**CHARTER TOWNSHIP OF ORION
PLANNING COMMISSION REGULAR MEETING AGENDA
WEDNESDAY, DECEMBER 7, 2022 - 7:00 PM
ORION TOWNSHIP MUNICIPAL COMPLEX BOARD ROOM
2323 JOSLYN ROAD
LAKE ORION, MI 48360**

4. <u>AGENDA REVIEW AND APPROVAL</u>	
5. <u>BRIEF PUBLIC COMMENT - NON-AGENDA ITEMS ONLY</u>	
6. <u>CONSENT AGENDA</u>	
7. <u>NEW BUSINESS</u>	
A. PC-22-46, GM Orion BET 2, Site Plan & Wetland Amendment, located at 4555 Giddings Rd., parcel #09-34-200-006 & parcel #09-34-400-001	27

8. <u>UNFINISHED BUSINESS</u>	
A. PC-2021-51, Kay Industrial Site Plan, located at 50 Kay Industrial Dr., parcel #09-35-400-033 - Elevations	152
B. PC-2021-52, Kay Industrial Site Plan, located at unaddressed parcel 09-35-400-044 (a parcel south of 100 Kay Industrial Dr.) - Elevations	165

C. PC-22-39, Hudson Square Planned Unit Development (PUD) Concept Plan, located at 3030 S. Lapeer Rd. (Sidwell #09-26-101-021).	175
9. <u>PUBLIC COMMENT</u>

1. Sheet G-004. Site Layout & Pavement Plan.

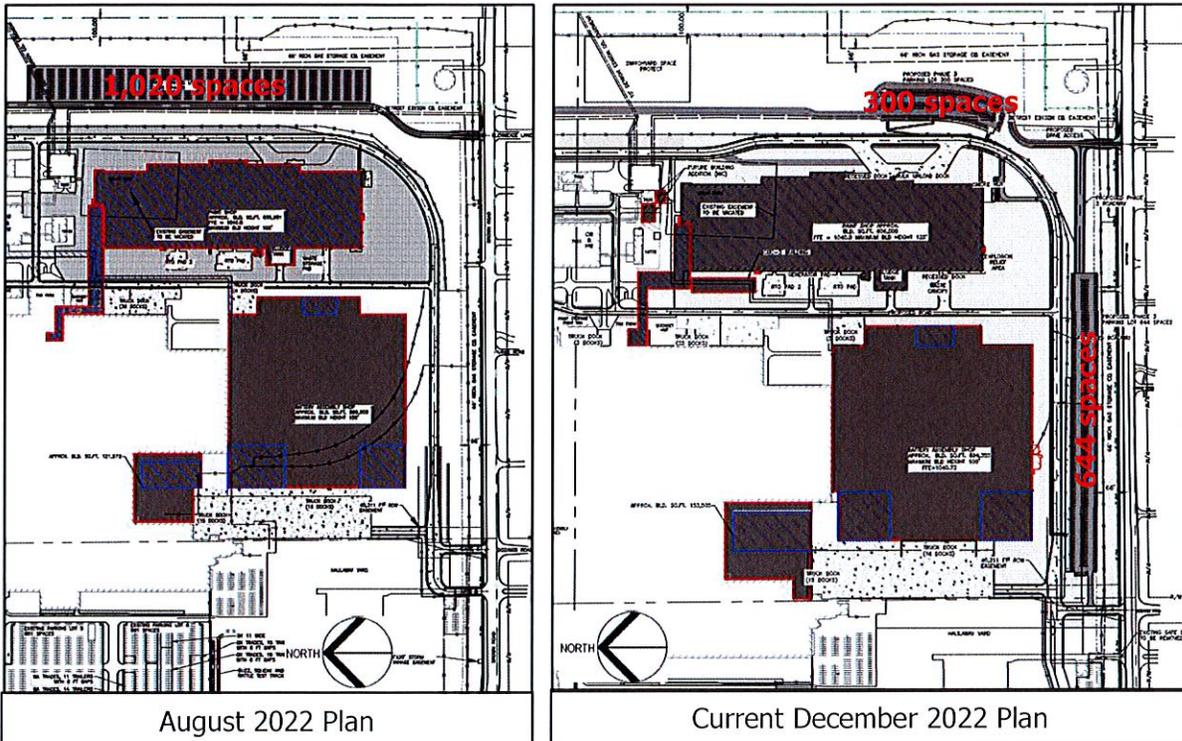
The realignment of the internal ring road maintains a setback from the north property line of approximately 32 feet and does not appear to impact the 50-foot greenbelt along Silverbell Road. The realigned roadway will tie back into the ring road network between the new body shop and temporary construction parking lot on the east side of the railroad tracks.

- 2) South and Southeast Parking Lot – The configuration of the proposed parking lots have been refined to support employee headcounts for location of work areas.

3. Sheet AE2-100.

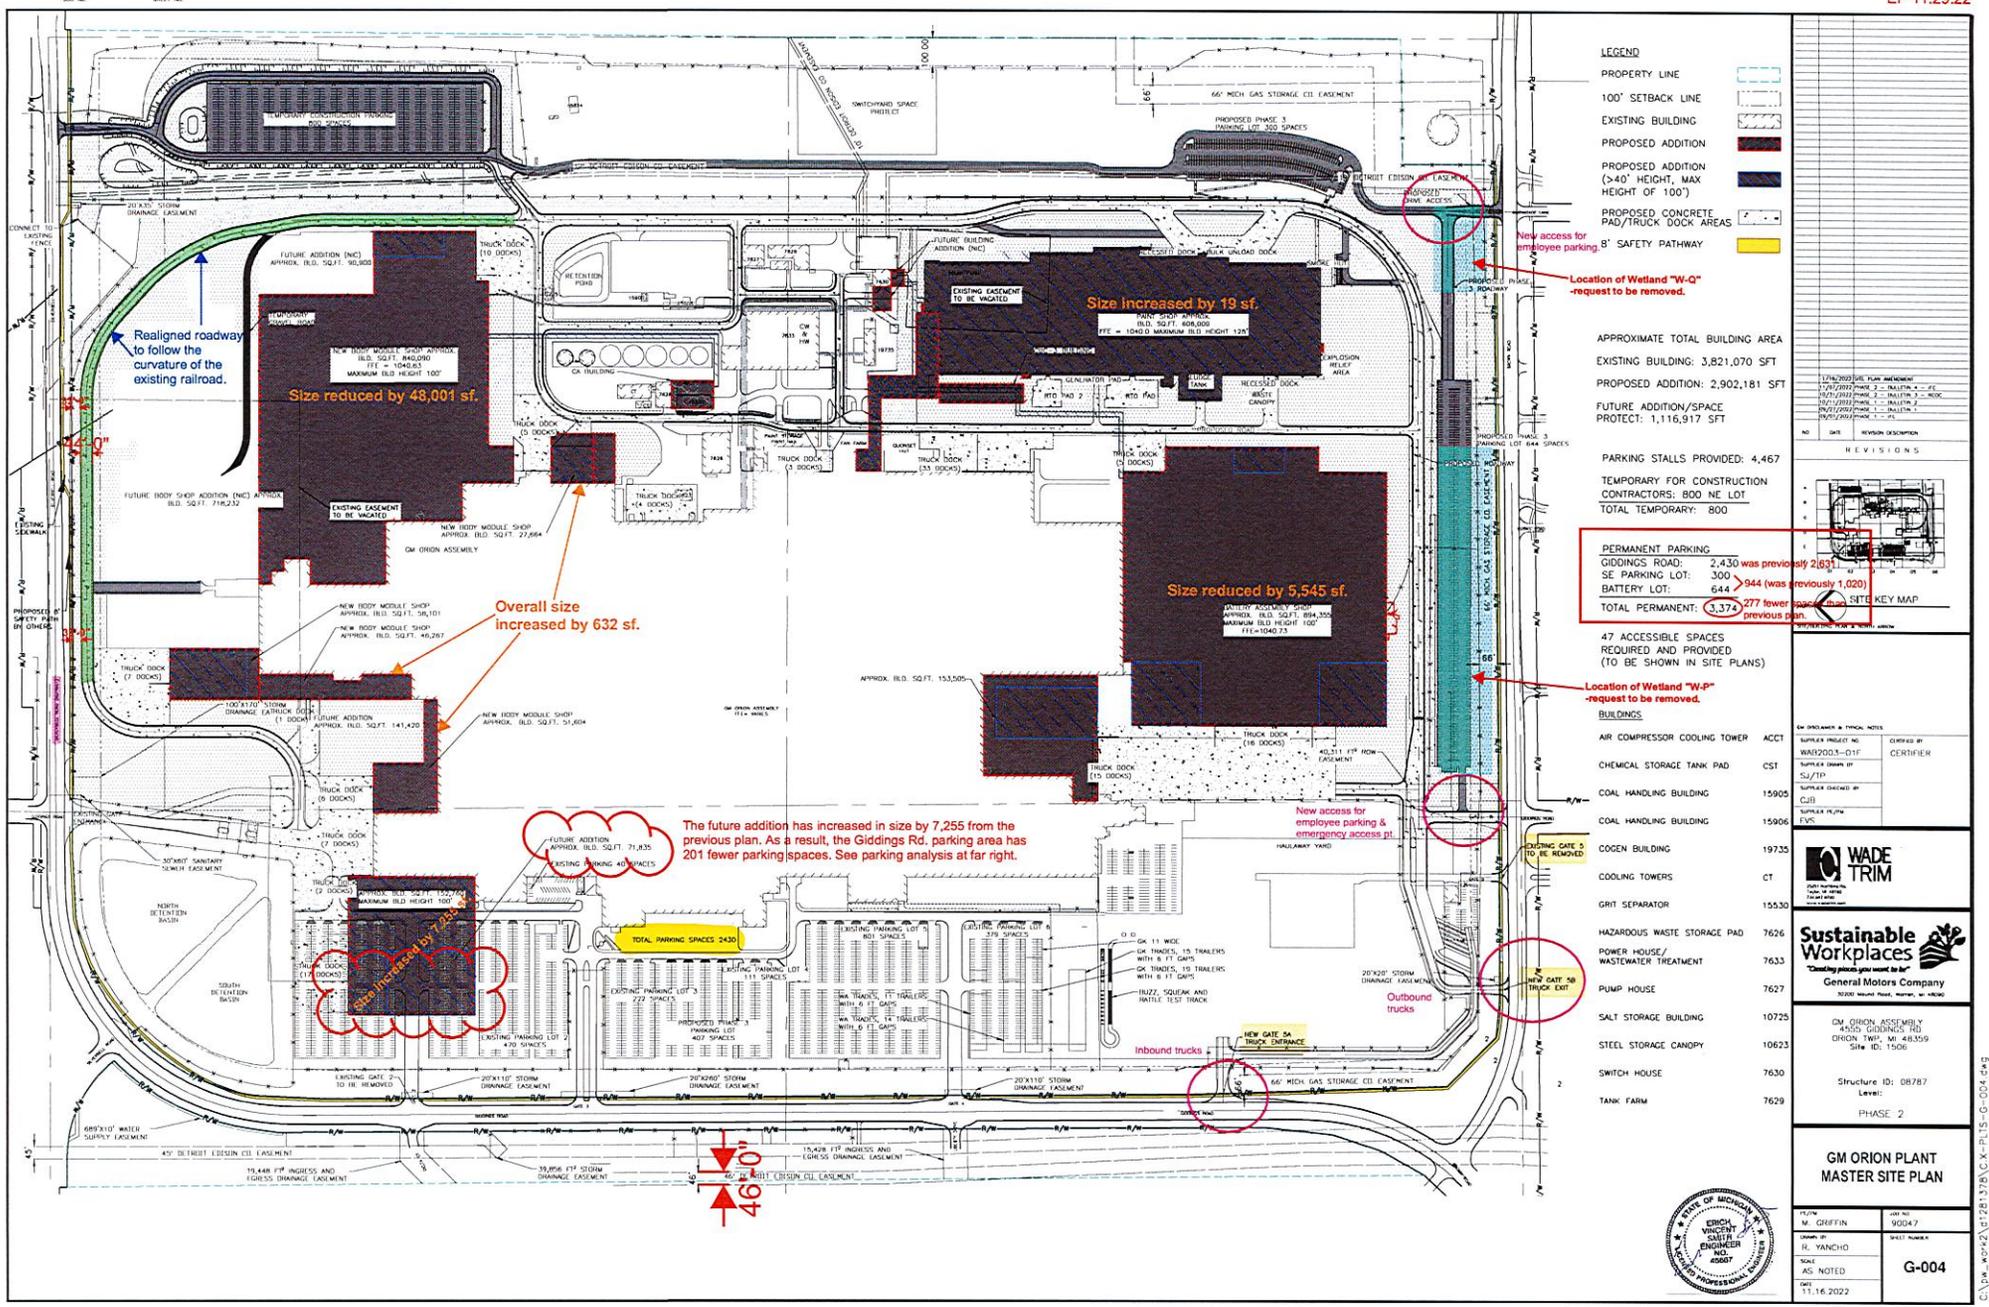
The proposed height of RTO Stacks to exceed the maximum height allowance, with variance request, is noted and observed on Sheet AE2-100. Additionally, we note that under Article 28, Section 2, ***any height requirement, variance, or waiver in excess of seventy (70) feet shall require mandatory approval of the Federal Aviation Agency.***

Snip from Existing Wetland Plan (Amended Sheet G-006)

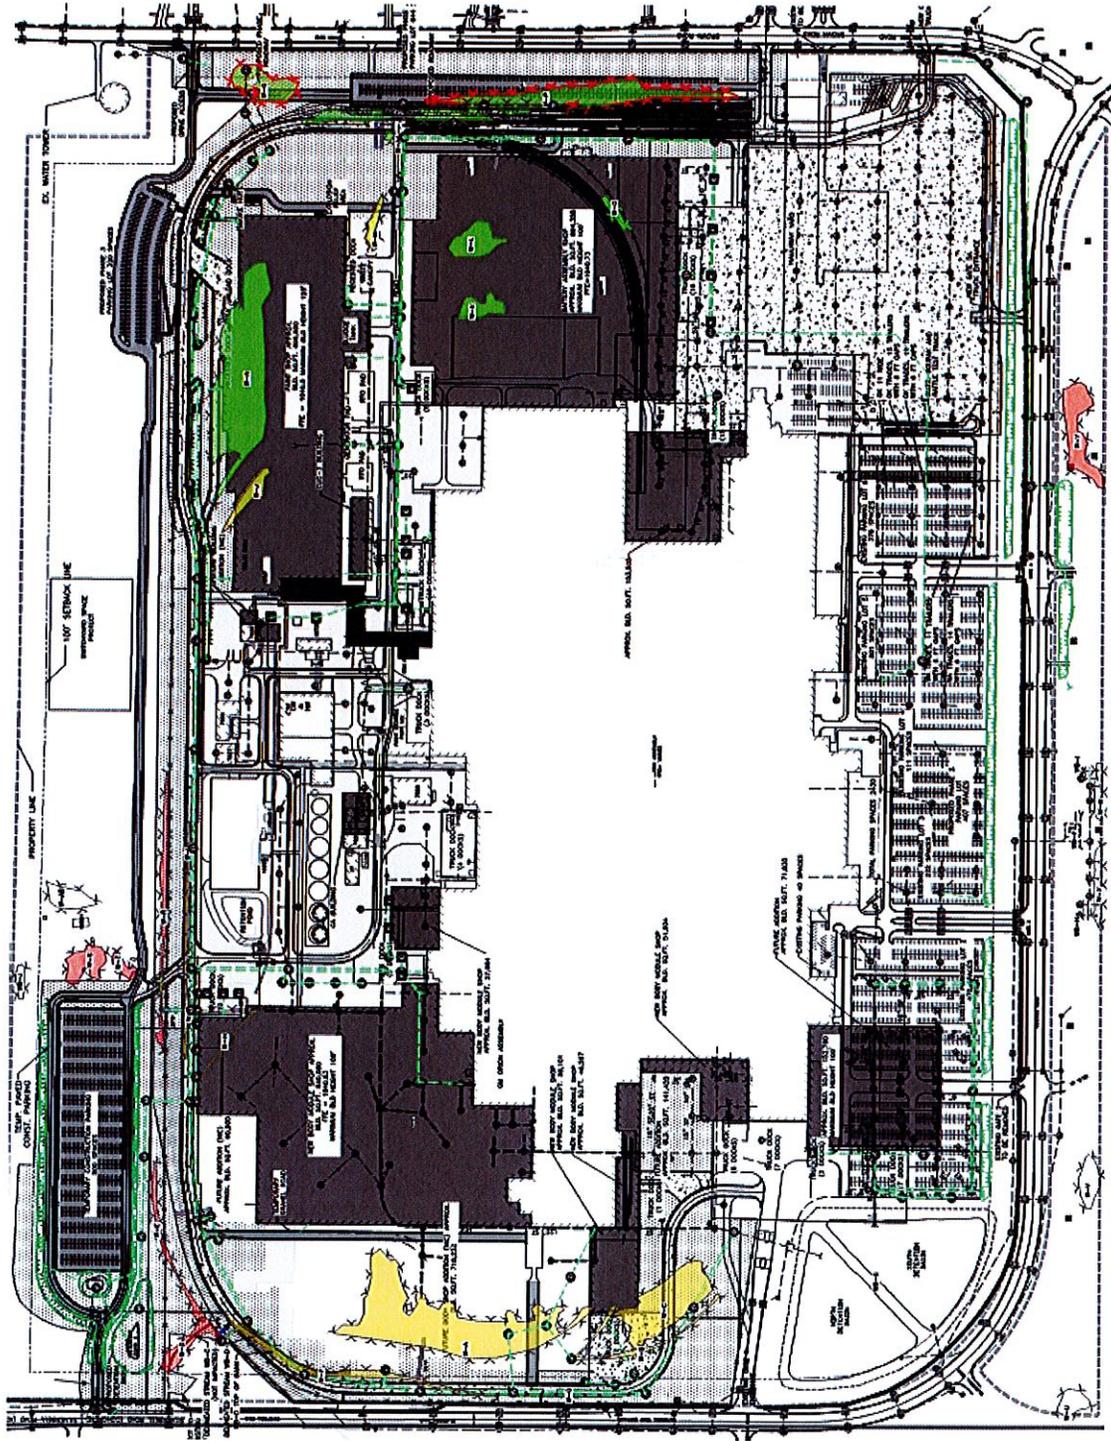
Excluding the wetland areas listed above, it appears that wetlands W-G, K, L, N, O, P, Q, and AA will be completely filled by the proposed improvements, totaling an additional 5.75 acres of wetland impacts. Wetlands W-U, and AB do not appear to be impacted by the proposed improvements. A table summarizing the wetland impacts was included on the Existing Wetland Plan (sheet G-006, shown above) in the site plan submittal.
